Product Bulletin

Product: 10326420 Lever - Screw Clamp Upgrade

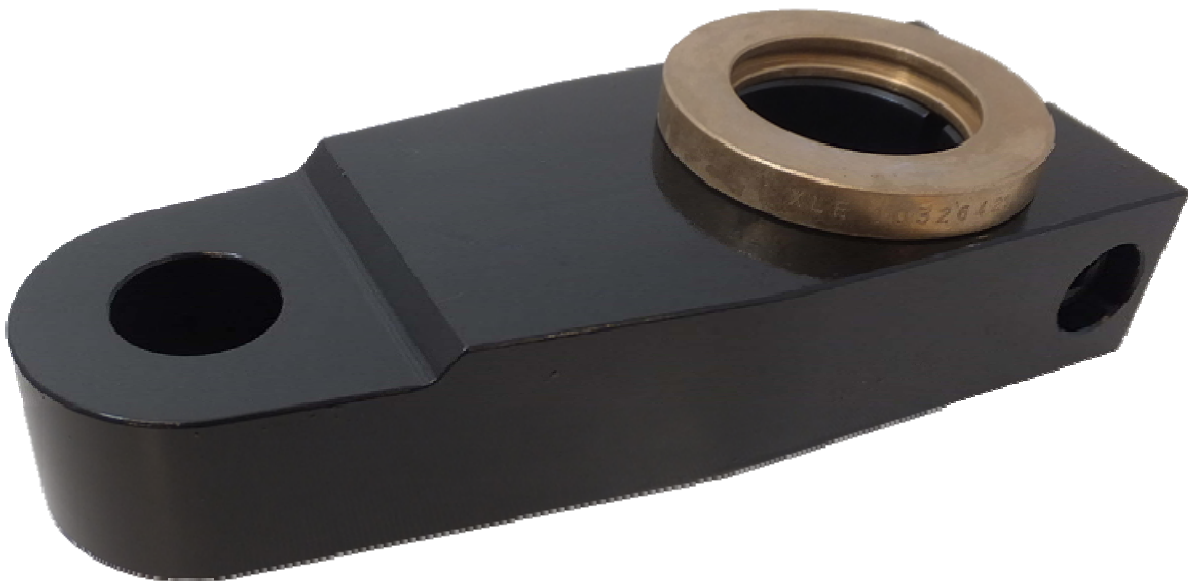
Description: This upgrade replaces the OEM Lever and Locking Collar with a simple single screw clamping feature. This design is intended to reduce downtime when a Lever becomes out of sync. The OEM Bearing Pin and hardware for the Roller Bearings are reused.
